THE CITY OF KEY WEST

ADDENDUM #2

Electrical Enclosures & Fuel Station

Invitation to Bid: 13-011

1 LOCATION SITE PLAN
1" = 30'

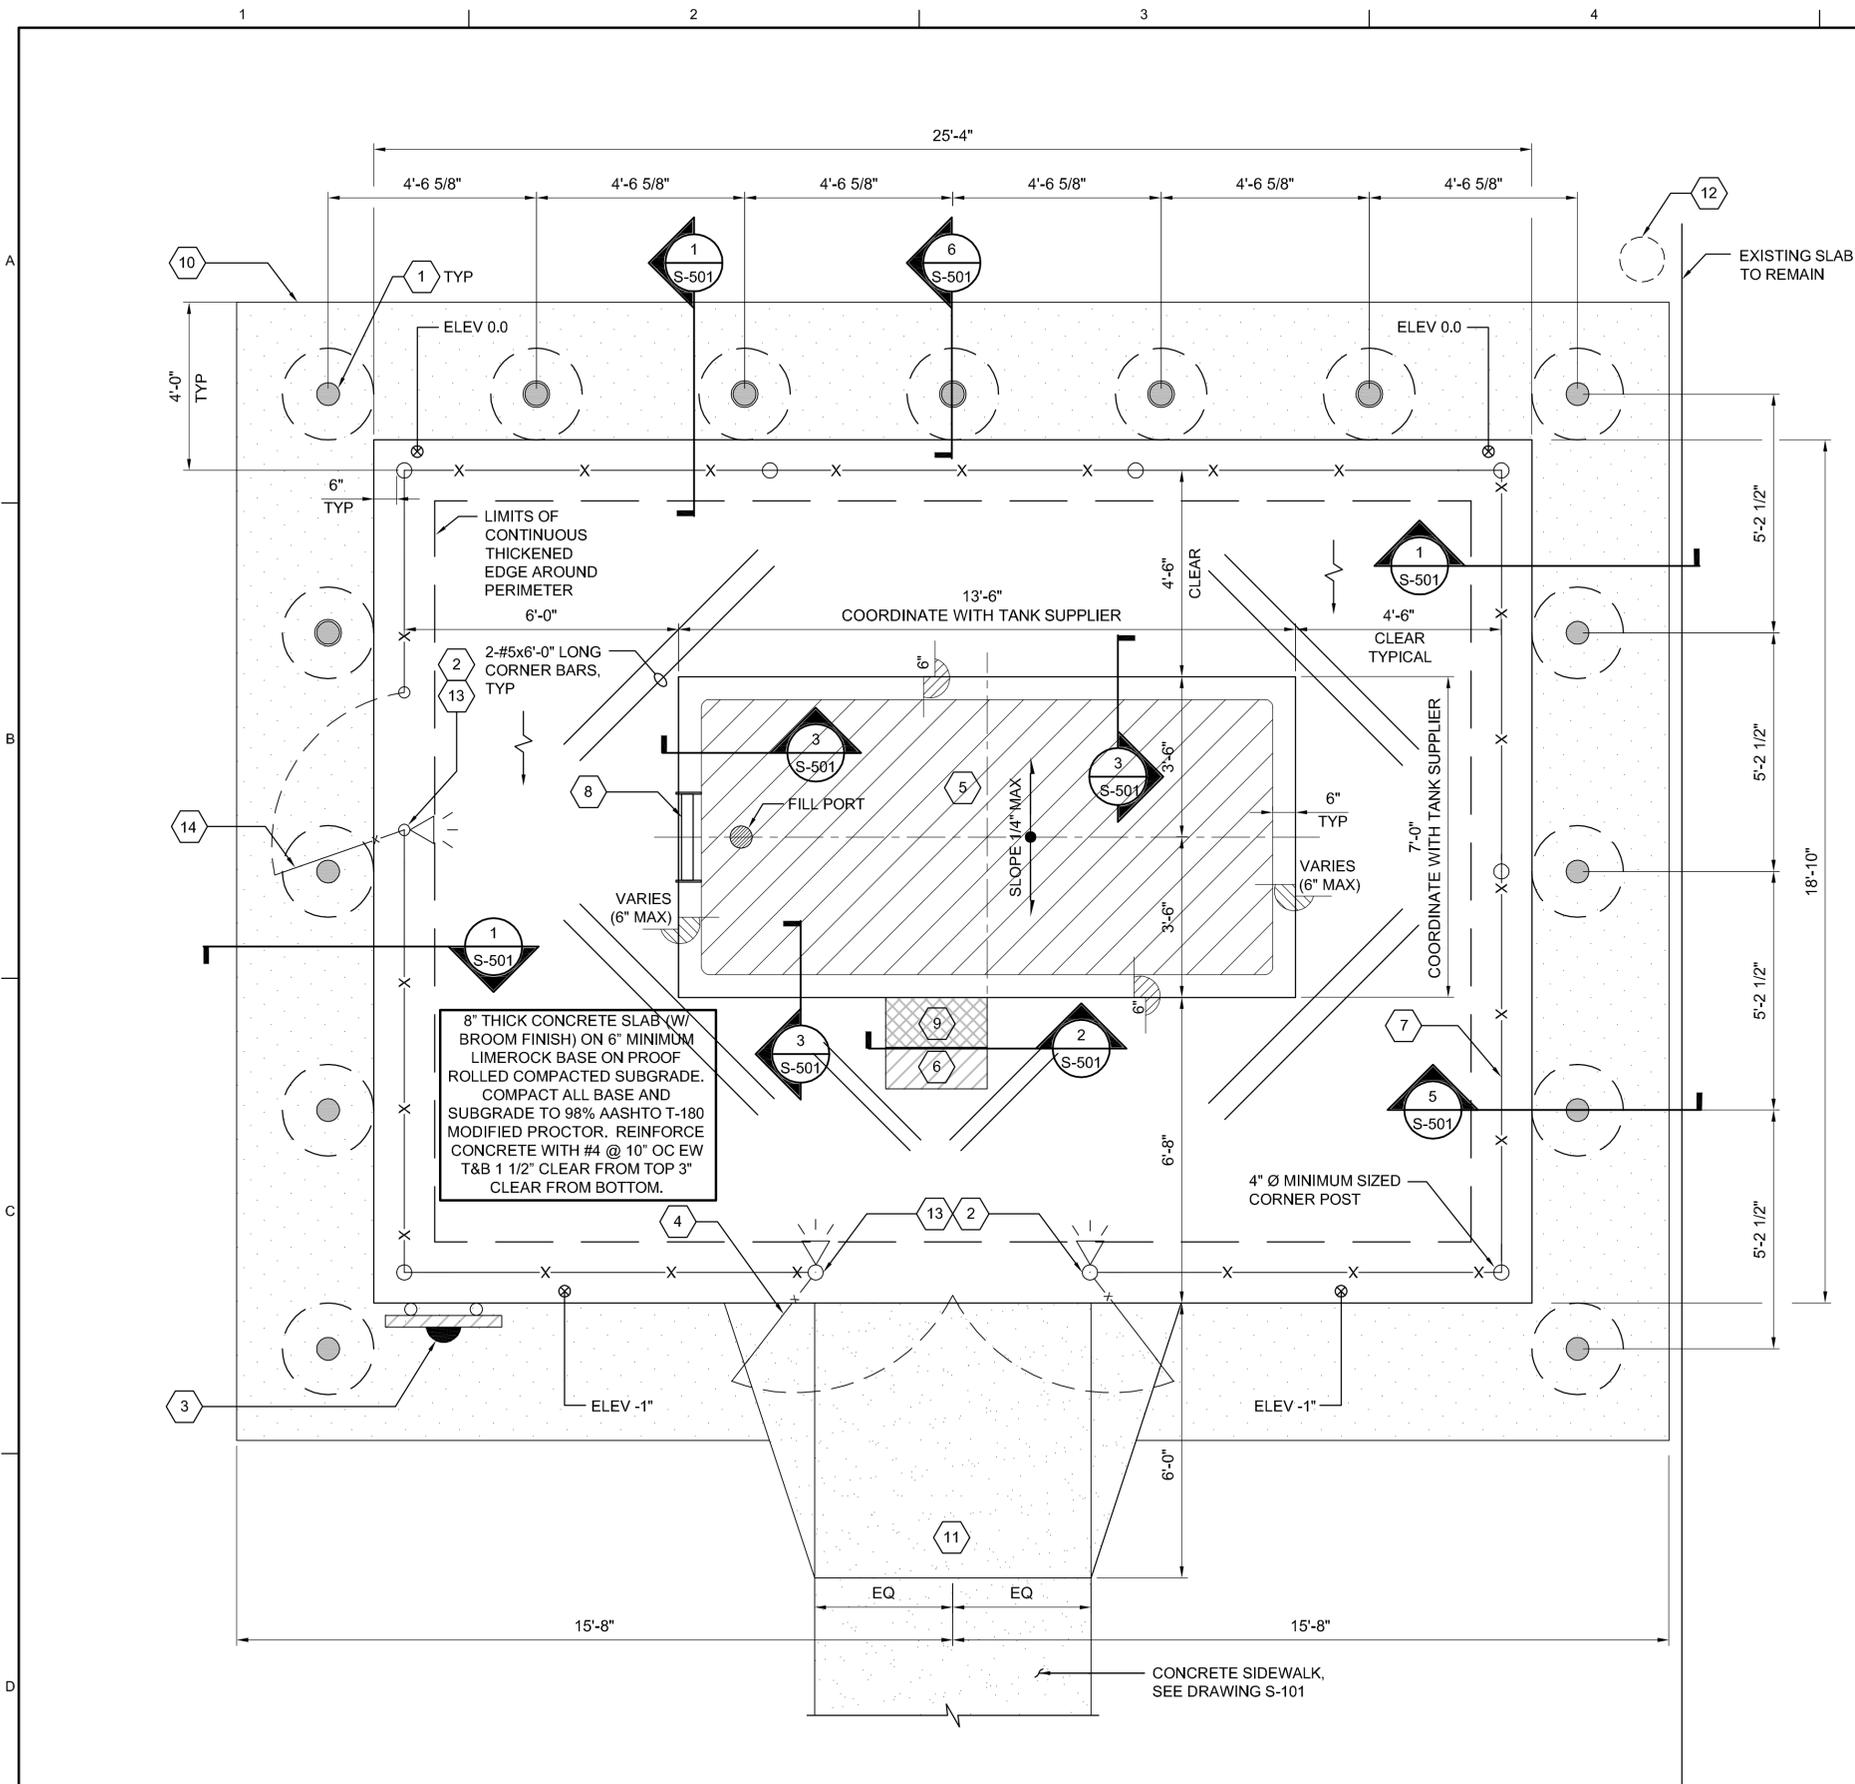
1. Replace Section F of Part 3 – Plans & Specifications with the attached (19 pages).
 - a. All work depicted on Sheets S403, S503, S504, S505, S506, S507, is to be excluded from this project in its entirety.

- b. Portions of Sheets S101 and E101 indicated are not a part of this project.
 - c. Any reference to “Floating Dock” and work associated with “Floating Dock” is not a part of this project.

NOT A PART OF ITB 13-011

SITE
**FLOATING DOCK CONNECTION
DETAILS SHEET 2**

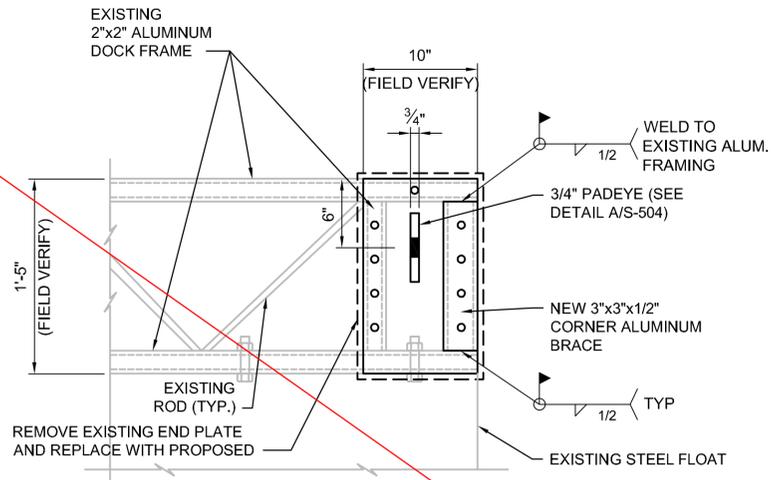
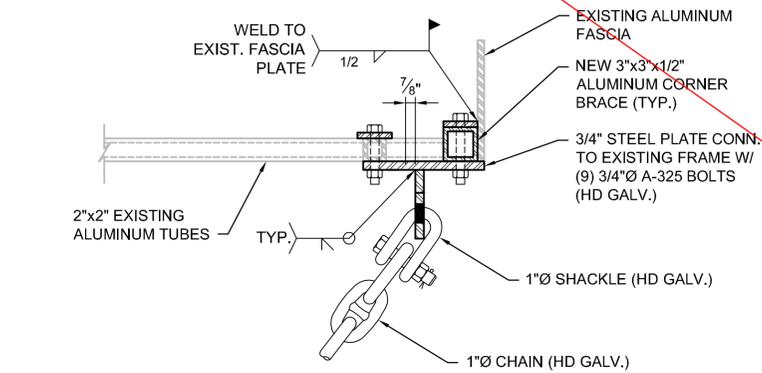
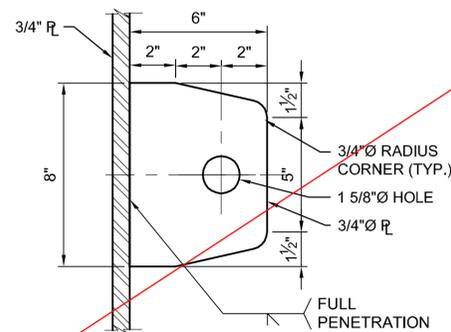
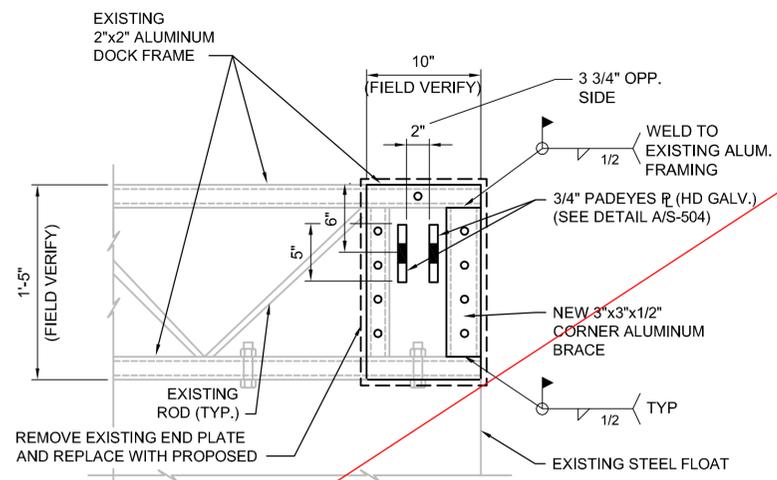
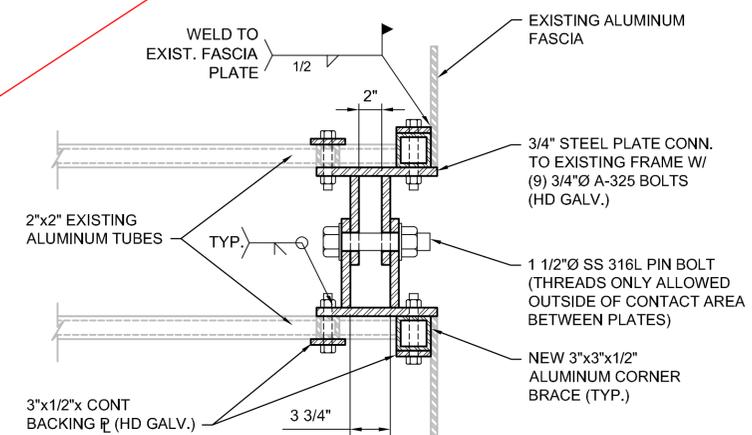
NOT A PART OF ITB 13-011
(THIS ENTIRE DRAWING)

DATE: JANUARY 25, 2012
PROJ: 460764
DWG: S-505
SHEET: 12 OF 19

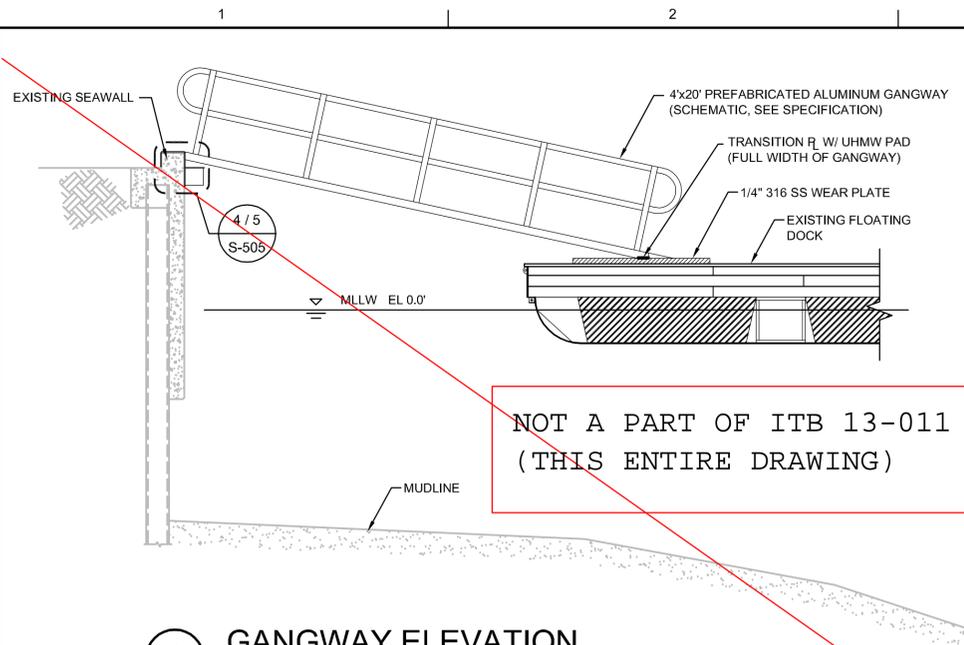
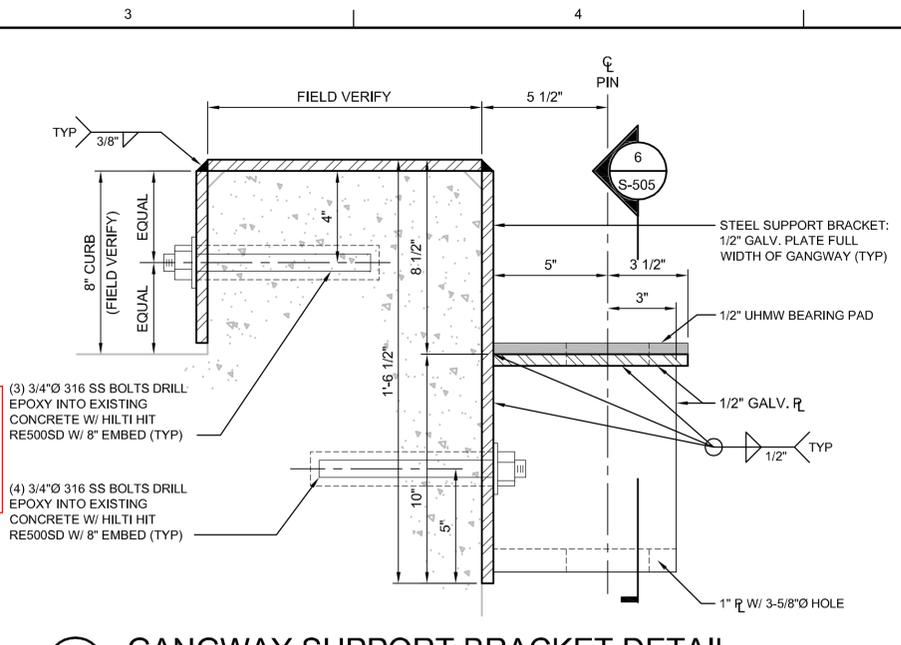
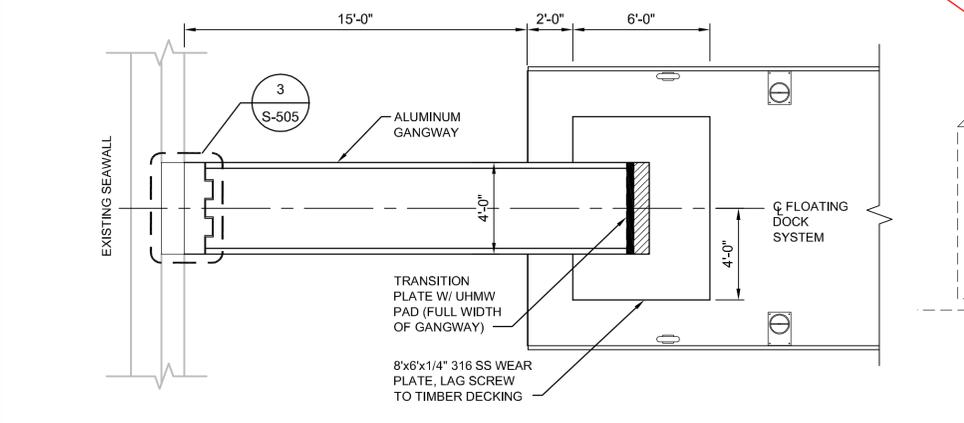
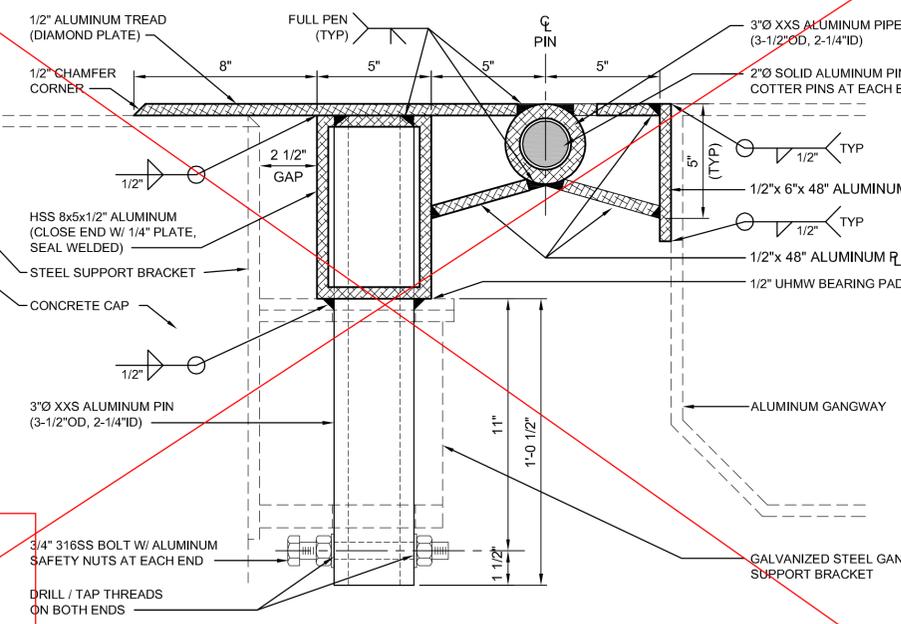
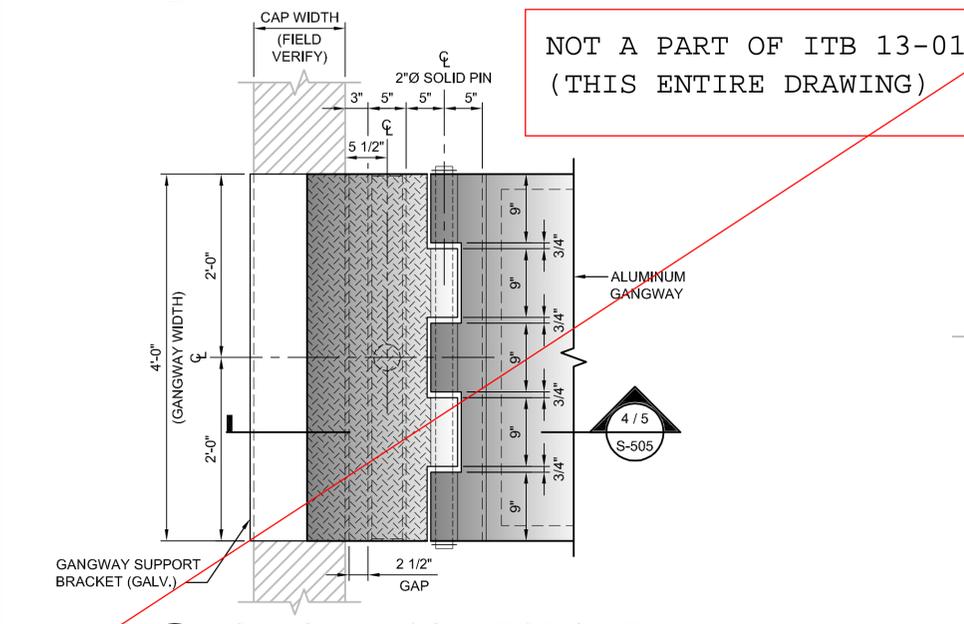
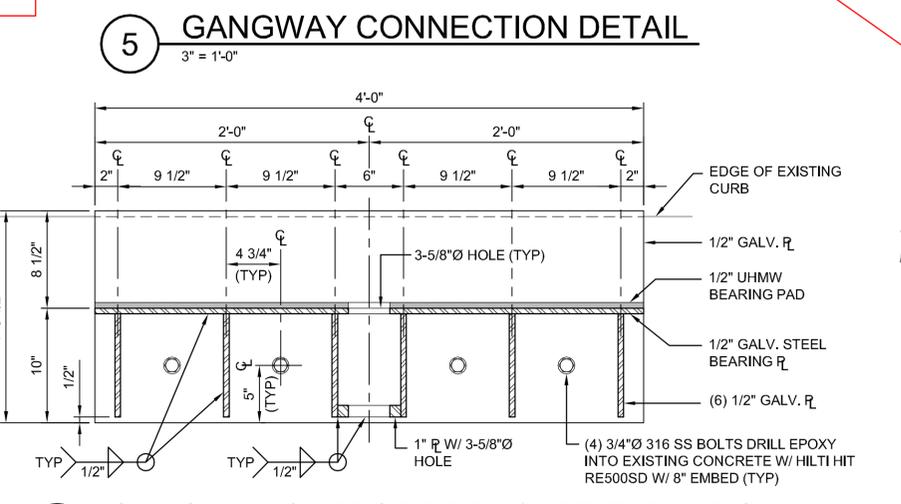
NOT A PART OF ITB 13-011
(THIS ENTIRE DRAWING)
